INAIL comments on Regulation (EU) No .../2012 of the European Parliament and of the Council on the approval and market surveillance of agricultural and forestry vehicles

Bruxelles 4 March 2013

Uncontrolled movement *Art. 18.2 (p) - Annex I item number 53*

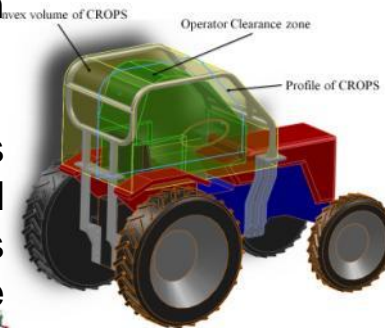
In Italy 10 fatal accidents per year occurred because of the uncontrolled movement of tractor while the operator was not at the controls.

Machinery Directive EHSR 3.3.2 first paragraph establishes that “all travel movements of self-propelled machinery with a ride-on driver must be possible only if the driver is at the controls”.

Amendment to EN 15694

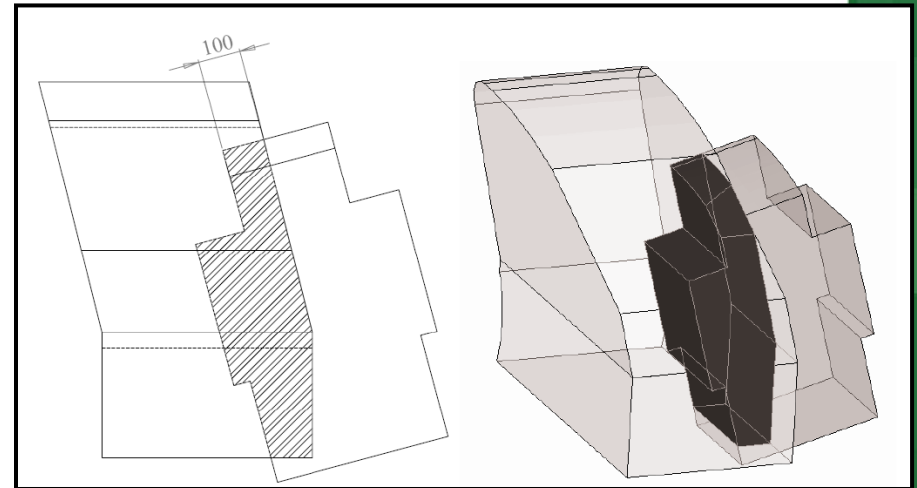
Considering the next amendment procedure of EN 15694 it is necessary to take into account the new requirements concerning passenger roll-over protection by means of a ROPS.

Seat belt anchorages *Art. 18.2 (i) - Annex I item number 47*

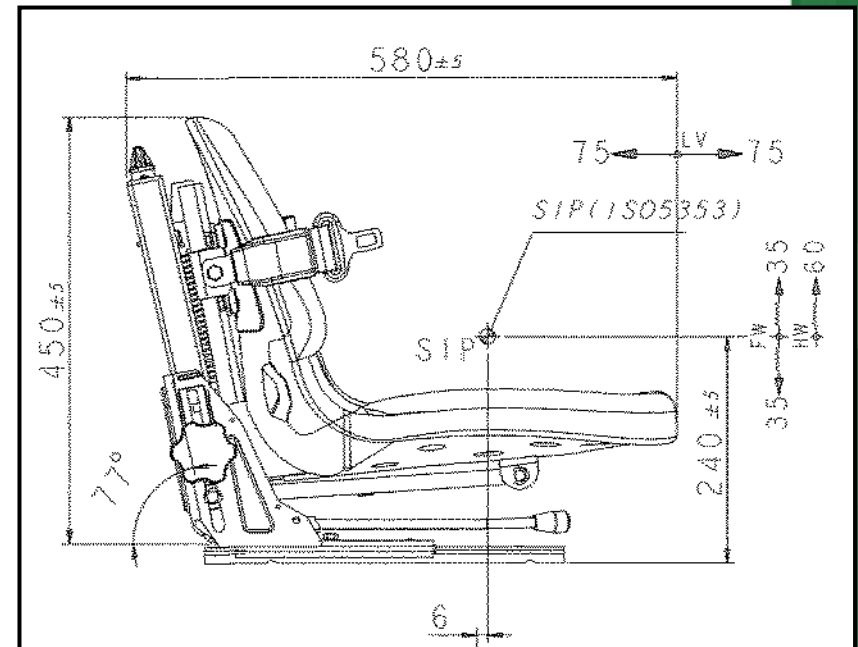
It is necessary to include anchorage location requirements as defined in ISO 3776-1 in order to avoid not ergonomic applications.

Safety and reliability of control system *Art. 18.2 (g) and (o) - Annex I items number 45 and 52*

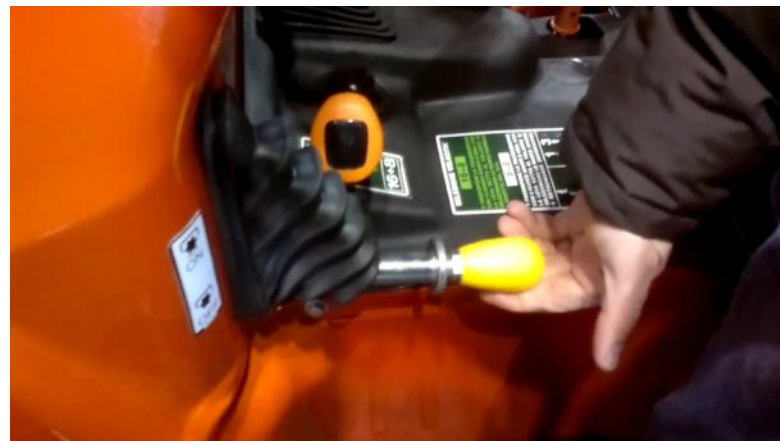
In Italy accidents occurred as a result of unexpected motion of the power take-off (PTO) due to mechanical failure of the locking system of the PTO clutch control.

The failure of the locking system was due in many cases to mechanical wear and lack of positive action principle.

Machinery Directive EHSR 1.2.1 establishes that *“control systems must be designed and constructed in such a way as to prevent hazardous situations from arising. Above all, they must be designed and constructed in such a way that they can withstand the intended operating stresses and external influences”*.
